ADDENDUM NO. 2

Date: August 18, 2014

Project: City of Tuscaloosa
City Walk at University Place and Forest Lake
Project No. A12-1413/A12-0993

| EROSION CONTROL PLAN | | | |

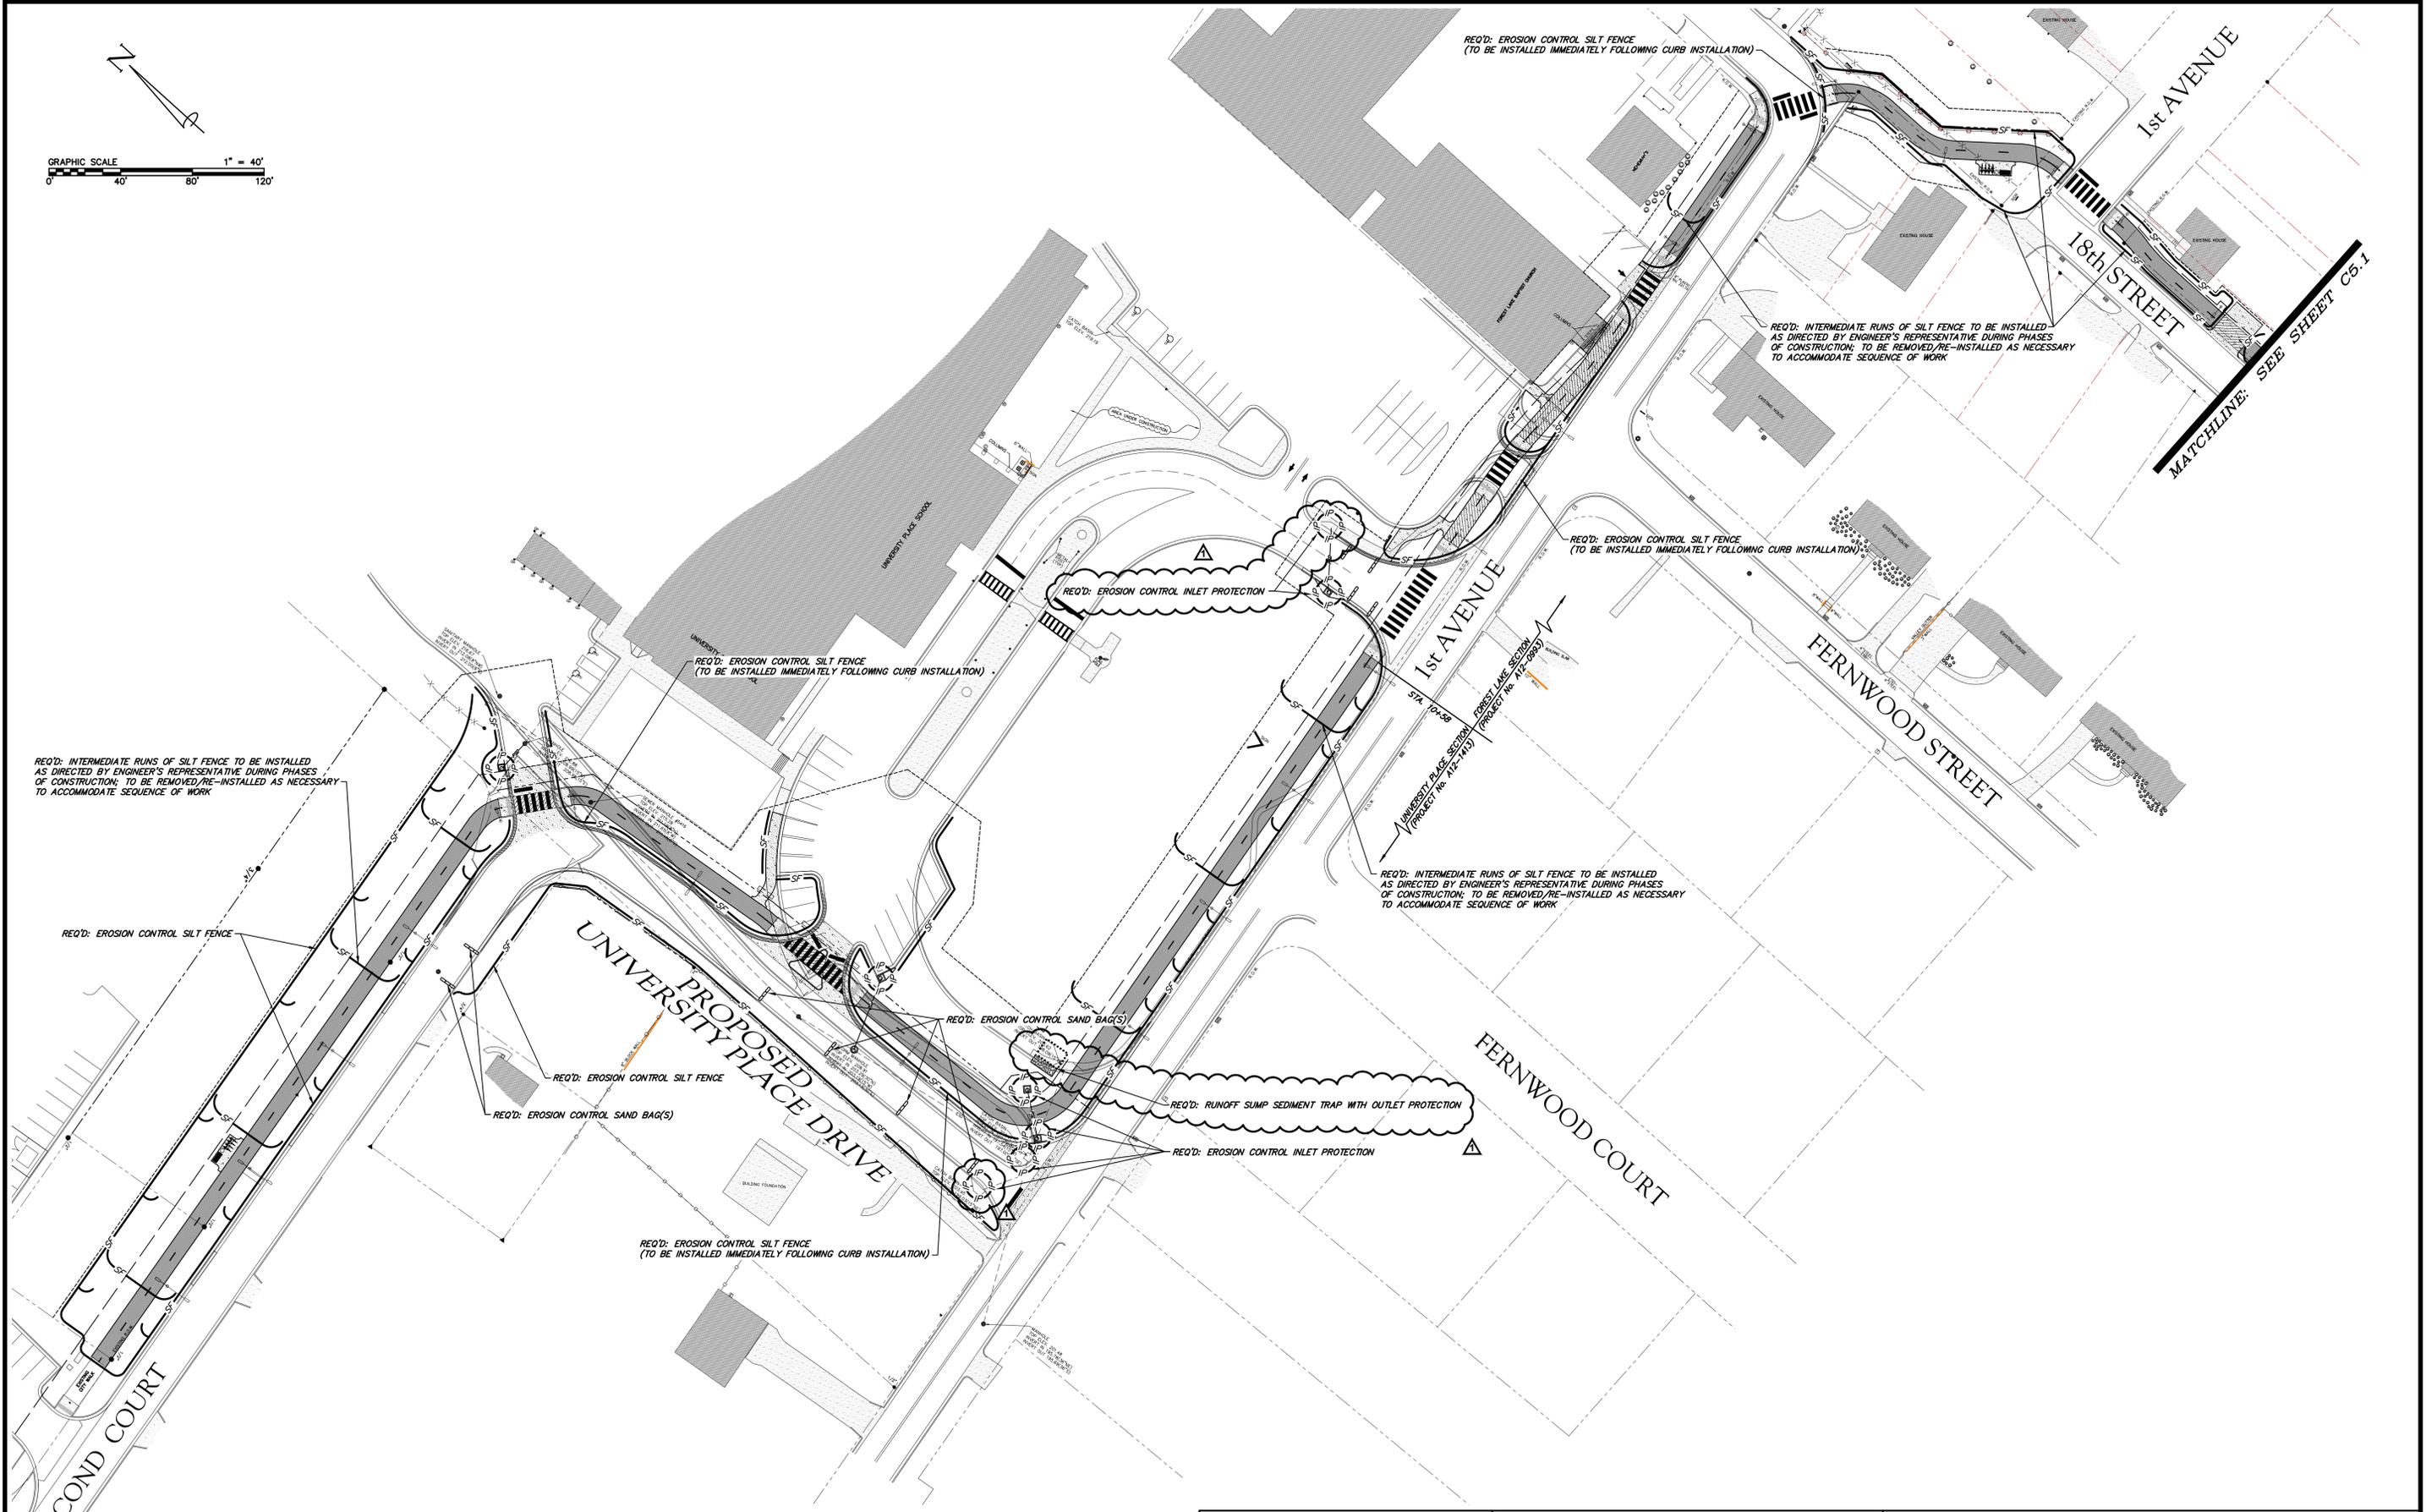
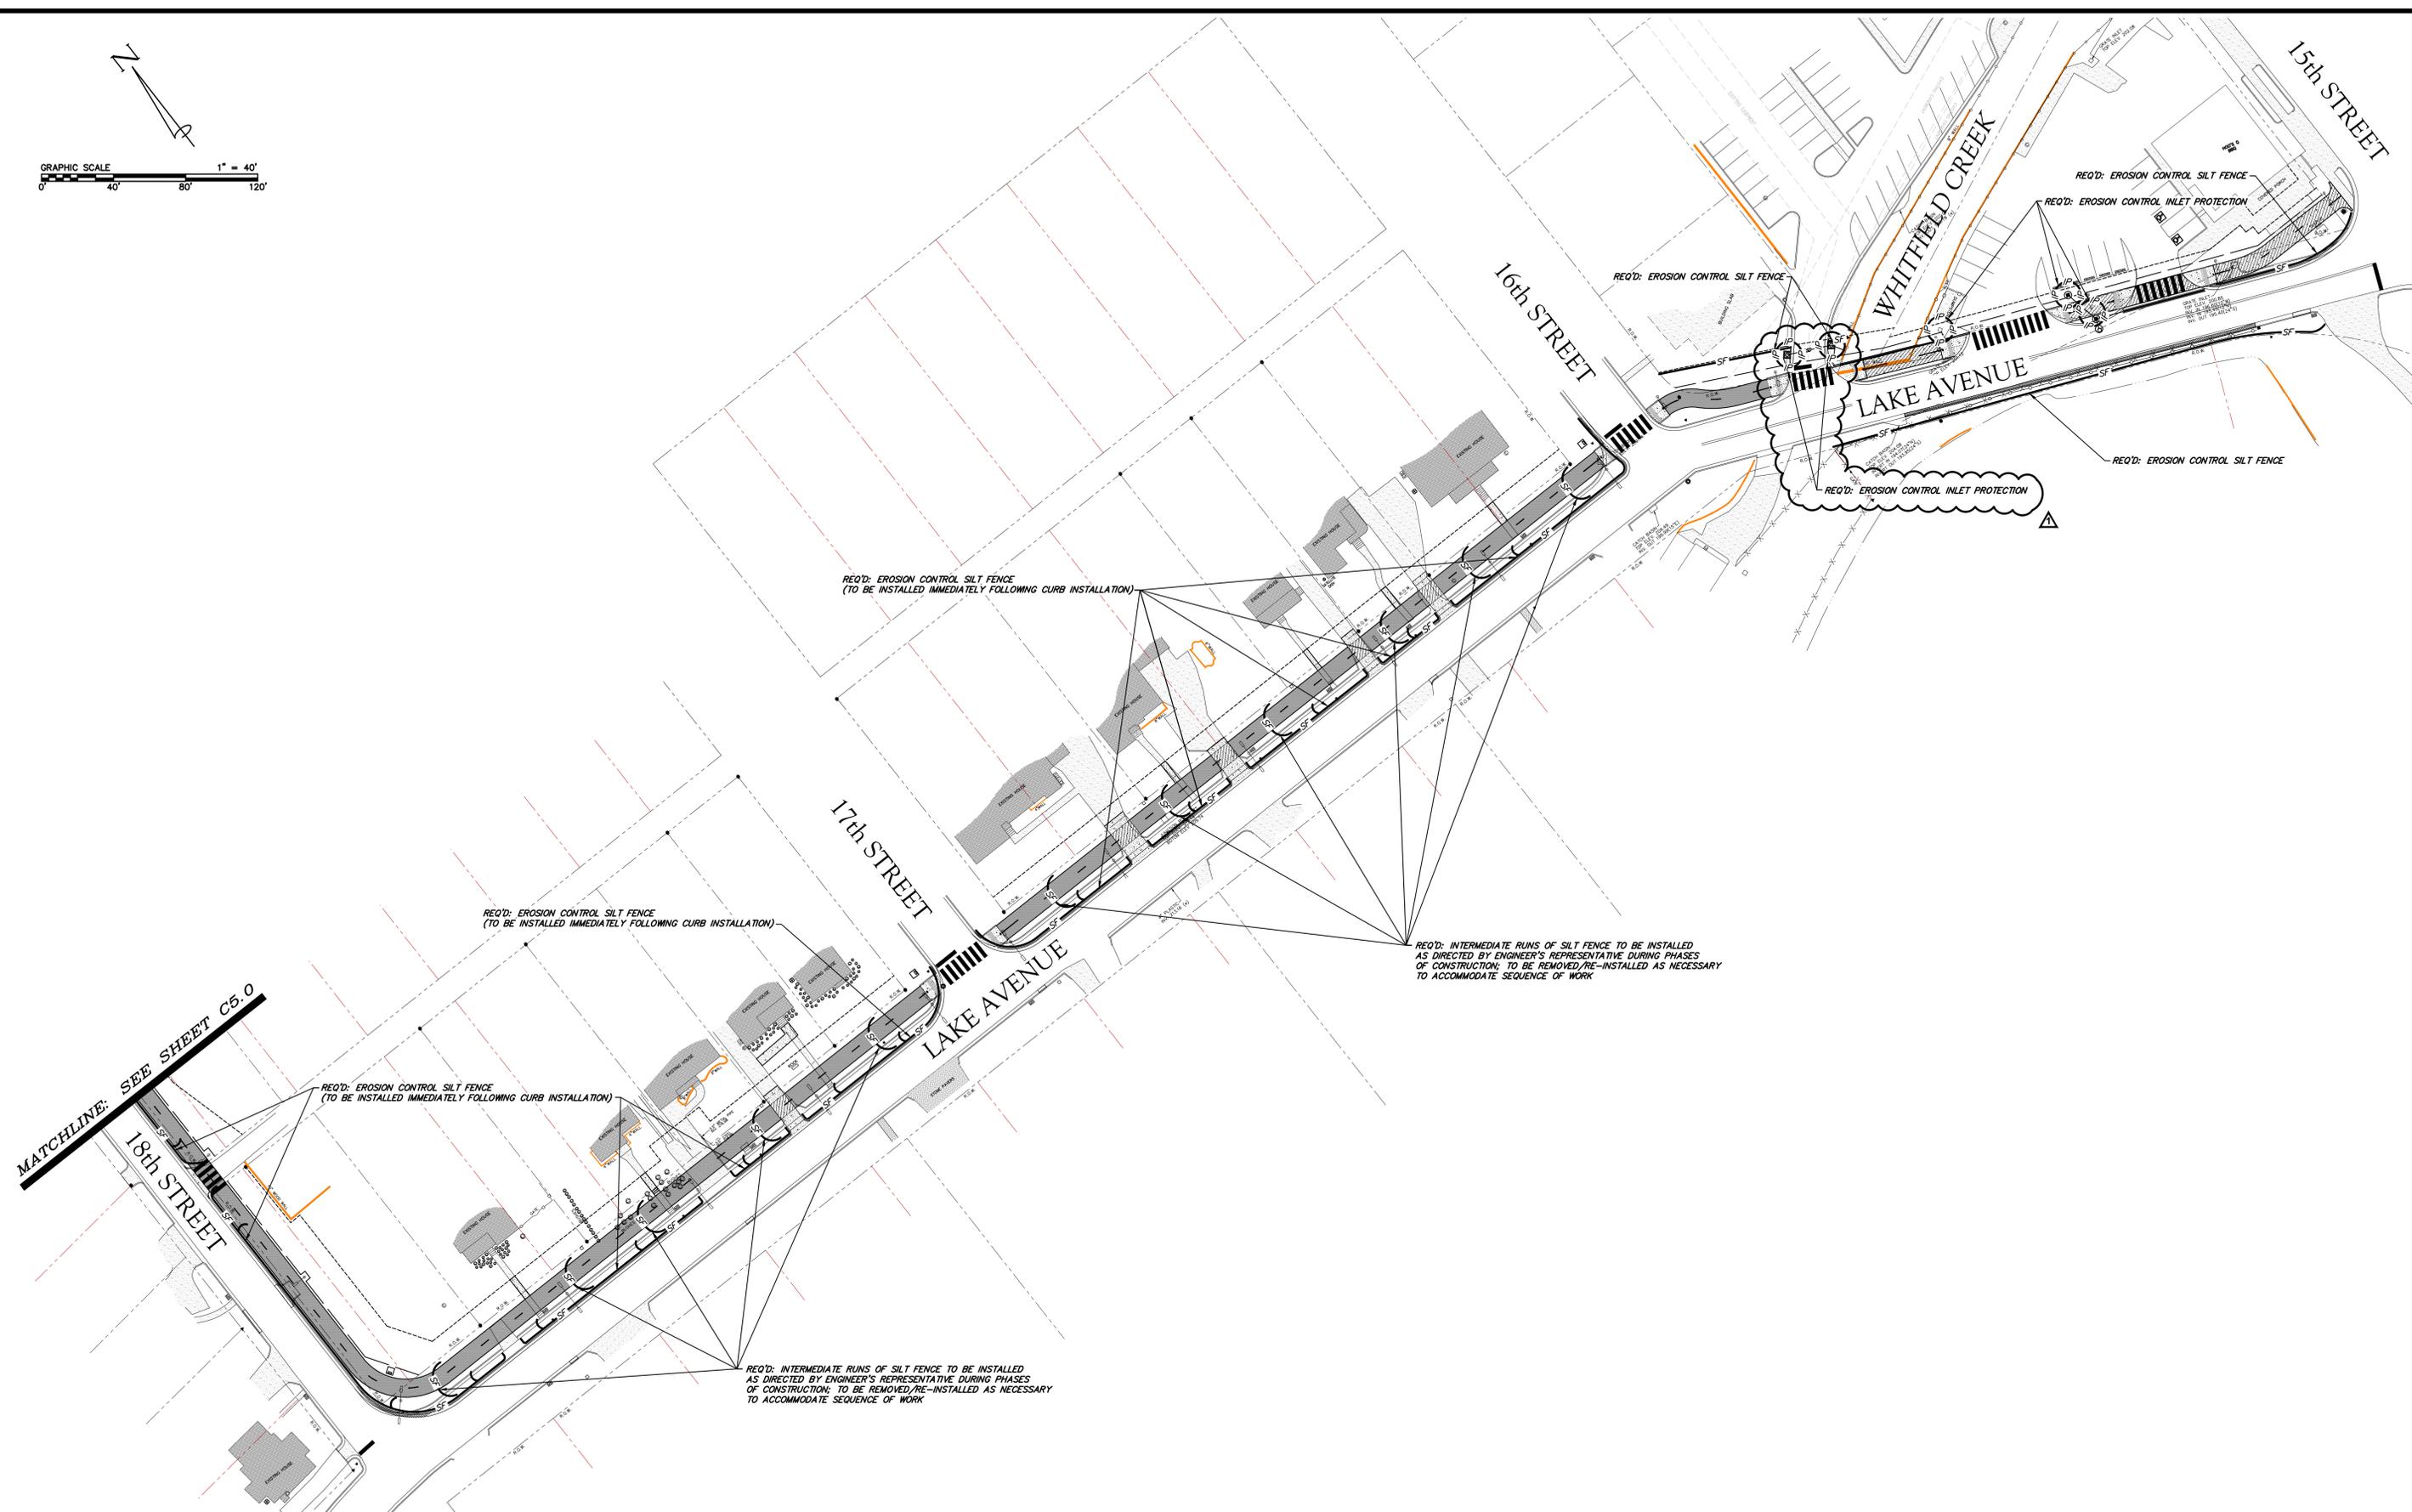
5. **Construction Plans:**
 - a) Sheet C2.0 – demolition of existing light pole assembly
 - b) Sheets C5.0, C5.1, and C8.7 – general revisions to erosion control plans (C5.0 and C5.1) and erosion/sedimentation control details (C8.7)

FIBER OPTIC DUCT BANK AND ELECTRICAL CONDUIT DETAIL

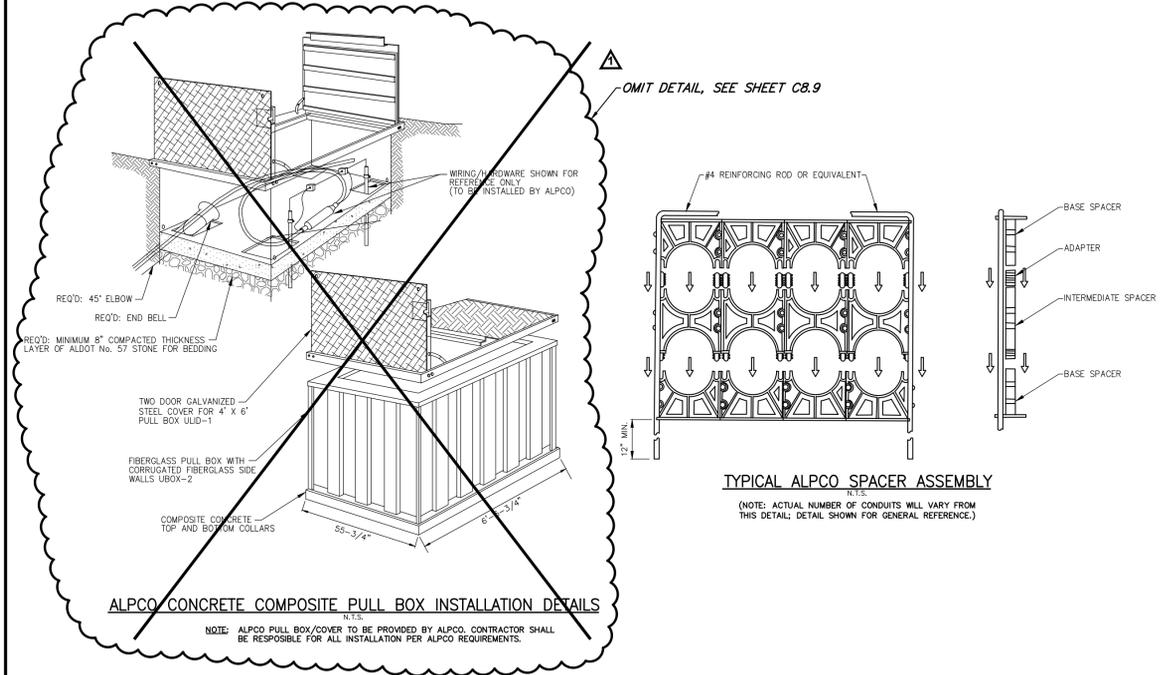
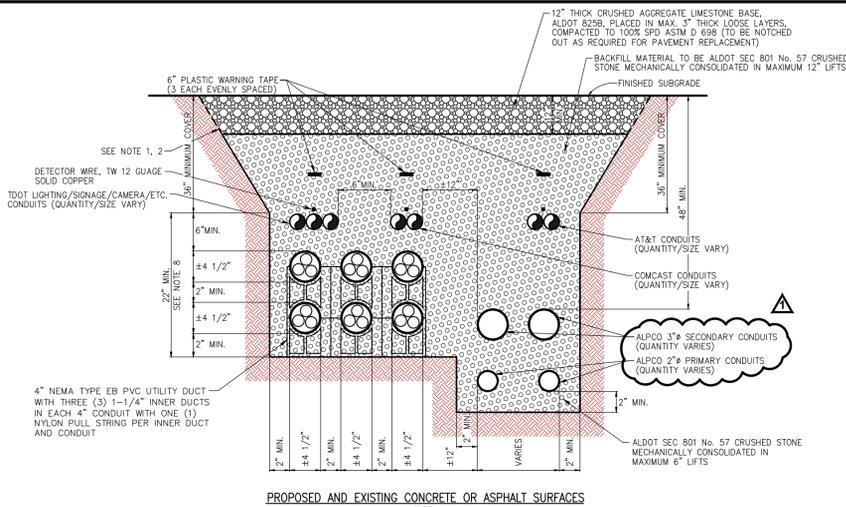
- c) Sheet C8.4 – elimination of duplicate ALPCO pull box details and duct bank trench revisions
 - d) Sheet C8.5 – modification of pole details
 - e) Sheet C8.9 – general modification of ALPCO details
